Project	<b>IEEE 802.16 Broadband Wireless Access Working Group</b> < <a href="http://ieee802.org/16">http://ieee802.org/16</a> >	
Title	Amendments to the Multi-hop Relay System Evaluation Methodology Document	
Date Submitted	2006-11-16	
Source(s)	Gamini Senarath, Mark Naden, Dean Kitchener, G.Q. Wang, Wen Tong, Peiyong Zhu Hang Zhang, David Steer, Derek Yu	Voice: 1-613-763-1315 [ <a href="mailto:wentong@nortel.com">mailto:wentong@nortel.com</a> ]
	Nortel 3500 Carling Avenue Ottawa, Ontario K2H 8E9	
Re:	Call for Technical Proposals regarding IEEE Project P802.16j (IEEE 802.16j-06/027)	
Abstract	Correction to the path loss models in 802.16j-06/.013r1	
Purpose	Address a missing path loss models and some editorial corrections to make the applicability of the models clear in P802.16j-06/13r1 document.	
Notice	This document has been prepared to assist IEEE 802.16. It is offered as a basis for discussion and is not binding on the contributing individual(s) or organization(s). The material in this document is subject to change in form and content after further study. The contributor(s) reserve(s) the right to add, amend or withdraw material contained herein.

# Amendments to the Multi-hop

Figure 3, BS-RS NLOS (ART to BRT)

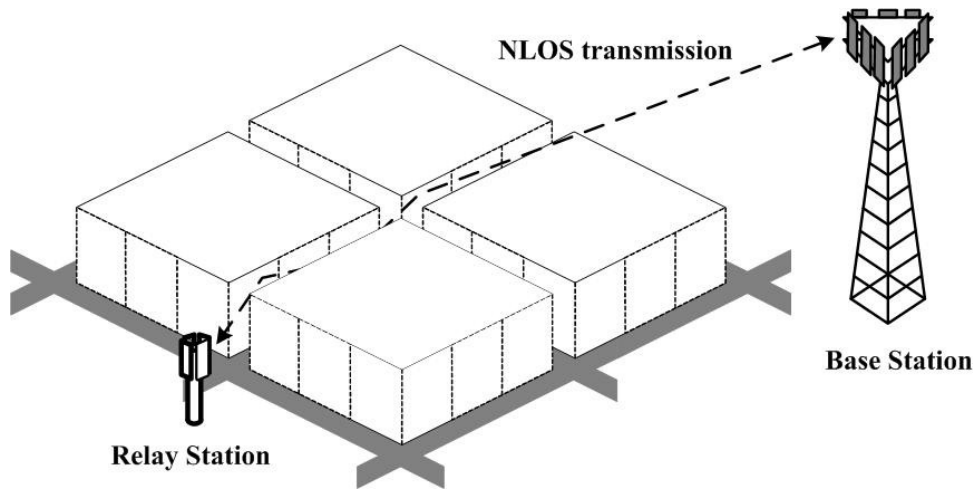
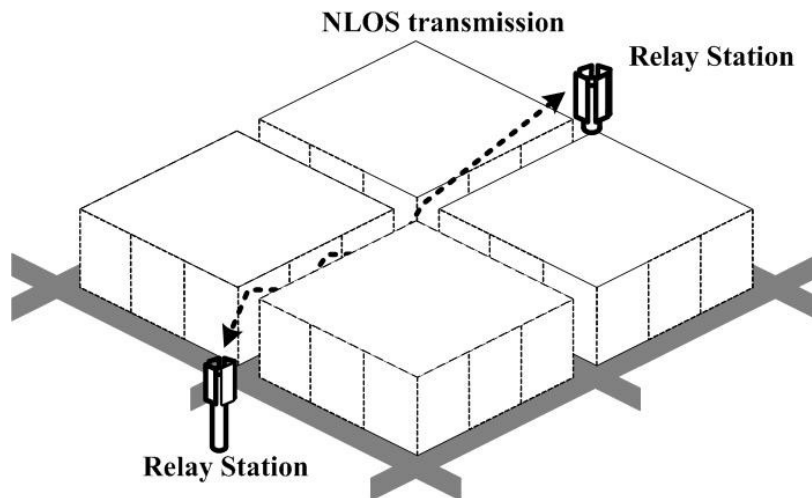
- c) The type E model does not have adequate parameters to be used for the simulations. In order to have alignment across different simulations we propose to have some parameters specified.

Proposed Text Change: Proposed Text Change: The Text marked in Blue color included in Section 2.1.2.3 below should be inserted into Type E model description in the 802.16j-06/013r1 document.

Parameter values to be used for this model are provided below. The use of these values is not mandatory.

*Building spacing,  $b = 60\text{m}$  (this is the spacing between building centers)*  
*Street width,  $w = 12\text{m}$  (this is the spacing between building faces)*  
*Street orientation = 90 degrees*  
*Average rooftop height,  $h_{\text{roof}} = 25\text{m}$*

Figure 5. RS-MS LOS Scenario

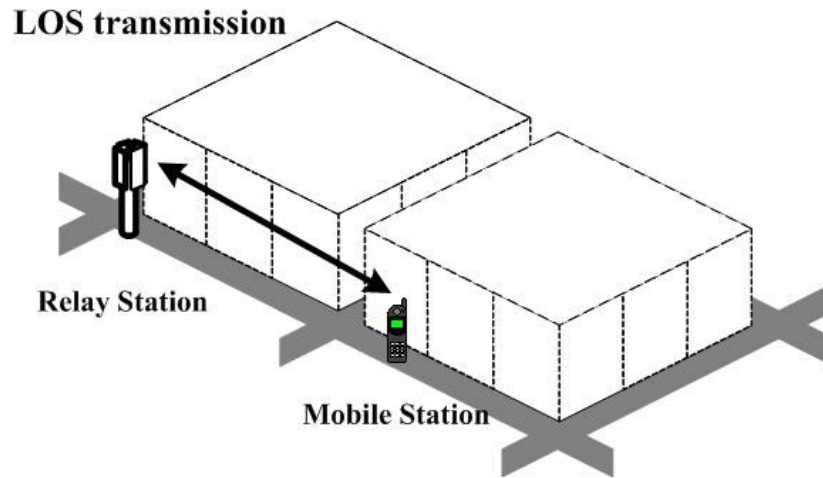
- e) Several headings of the subsections to be changed to reflect the above changes and Type F LOS and NLOS be covered under the same Type F Section as two subsections.

[Editor's note: Two subsections 2.1.2.4.1 and 2.1.2.4.2 are to replace 2.1.2.4 and 2.1.2.5 in the original document]

##### 2.1.2.4.1 LOS version:
